# **MONITORING YEAR 1 ANNUAL REPORT**

## **CANDY CREEK MITIGATION SITE**

RE: Draft Monitoring Year 1 Report Comments  
Candy Creek Mitigation Site (DMS #96315)  
DMS Contract Number 5794  
RFP Number 16-005568  
Guilford County, NC

We have reviewed the comments on the Monitoring Year 1 Report for the above referenced project dated January 9, 2018 and have revised the report based on these comments. The revised digital files are submitted with this letter. Below are responses to each of your comments. For your convenience, the comments are reprinted with our response in italics.

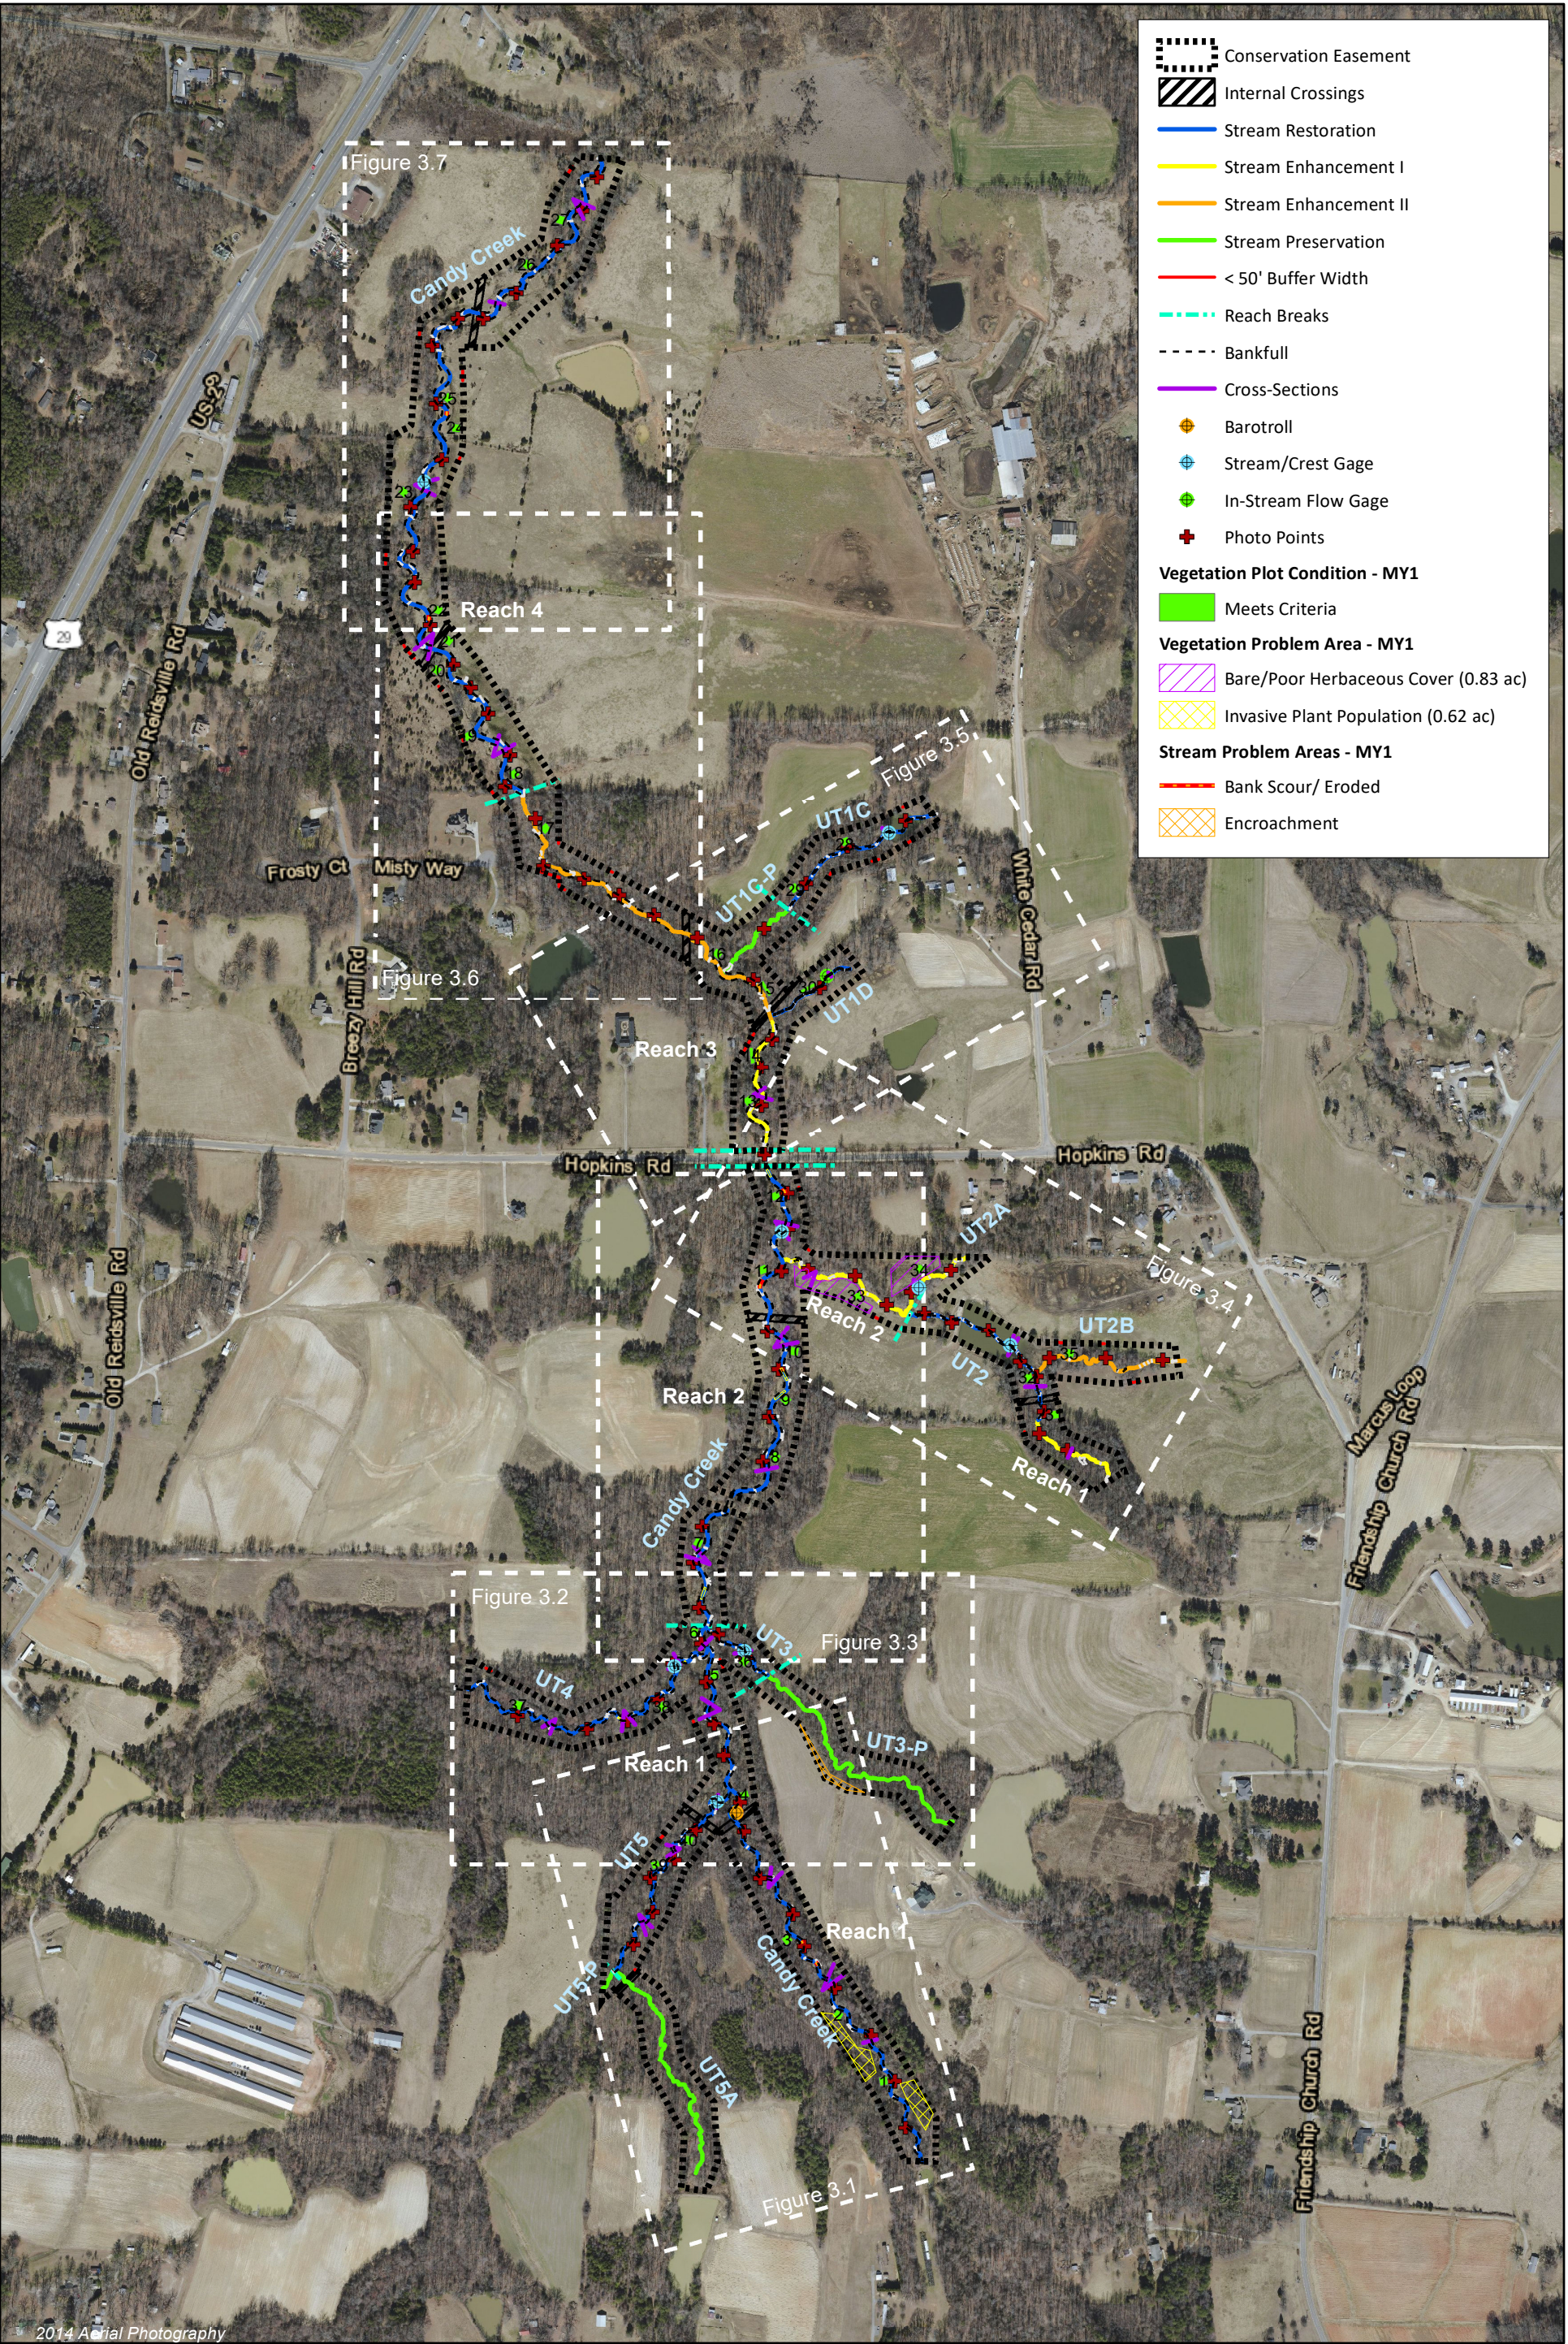
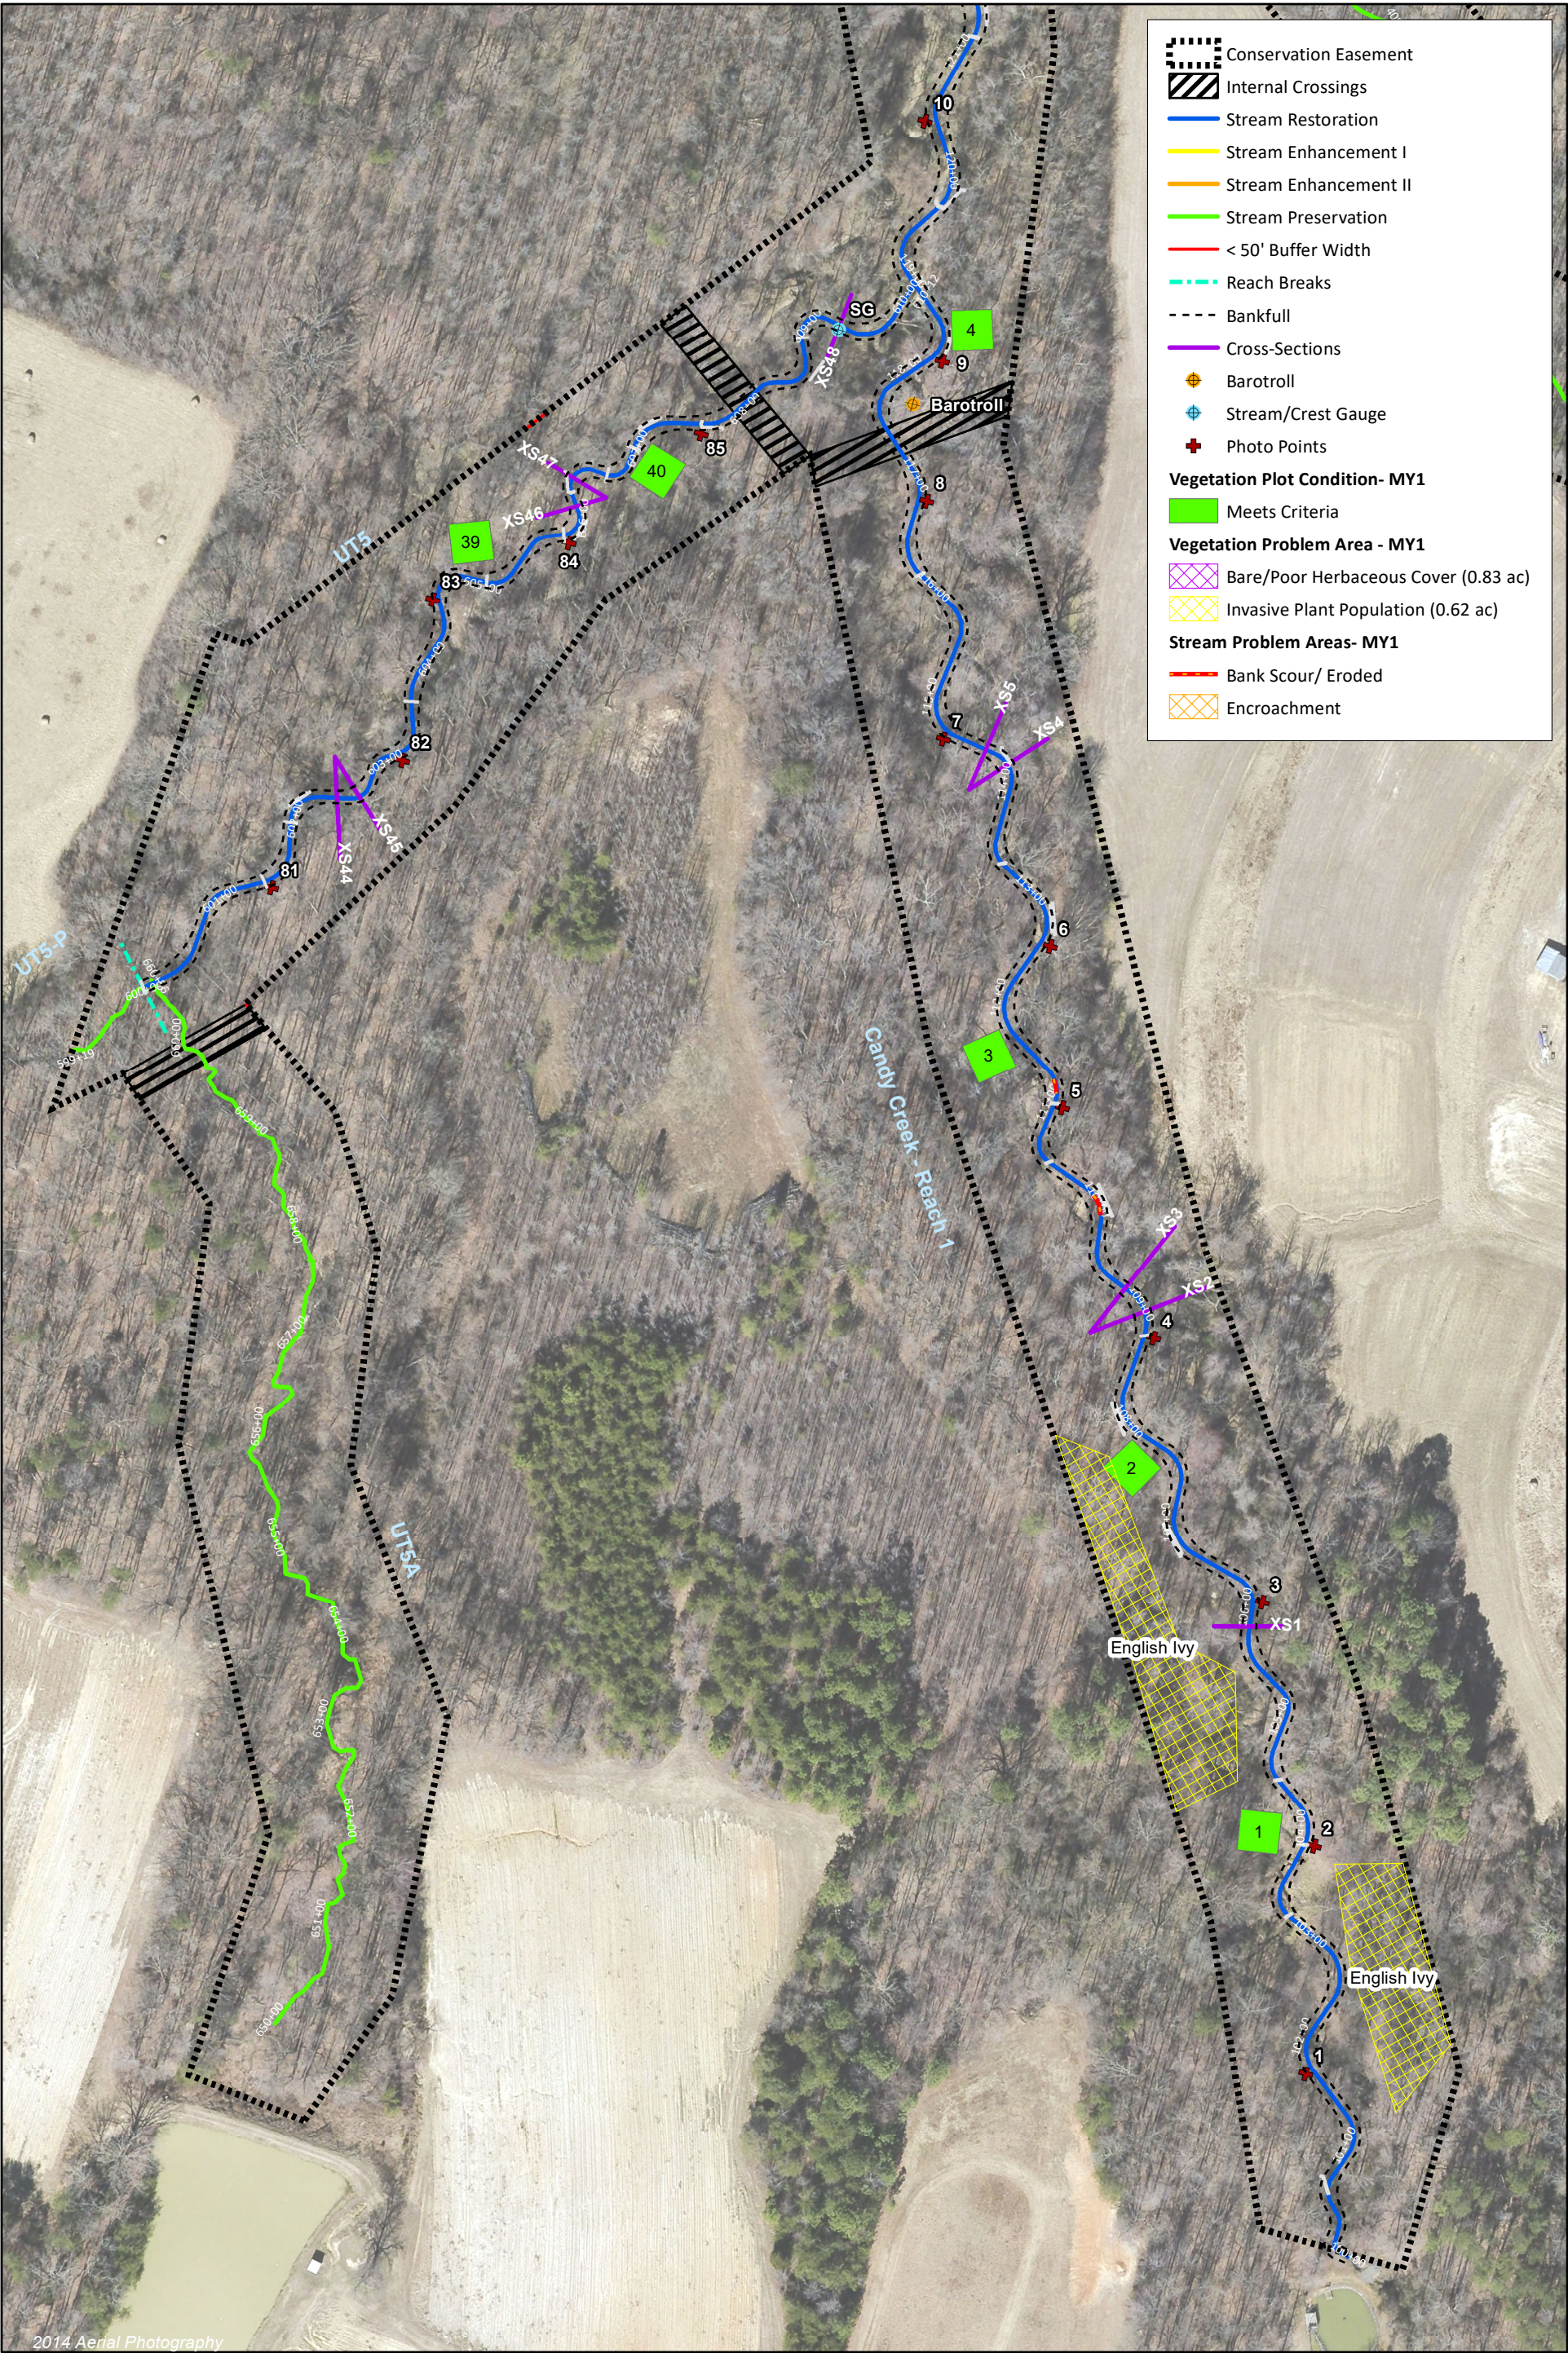
3. The CCPV shows sections along Candy Creek Reach 1, UT4, UT5, Candy Creek Reach 2, UT2 Reach 1, Candy Creek Reach 3, UT1C and Candy Creek Reach 4 where the buffer width is less than 50 feet. Wildlands addressed this in the As-Built Baseline report and indicated that the total length of these sections is approximately 3.1% of the total project length. Please address this in a sentence or two in the MY1 report and include that this is less than the 5% allowed by the IRT.

*An explanation was added to the end of the executive summary, page ii and section 1.2, page 1-2.*
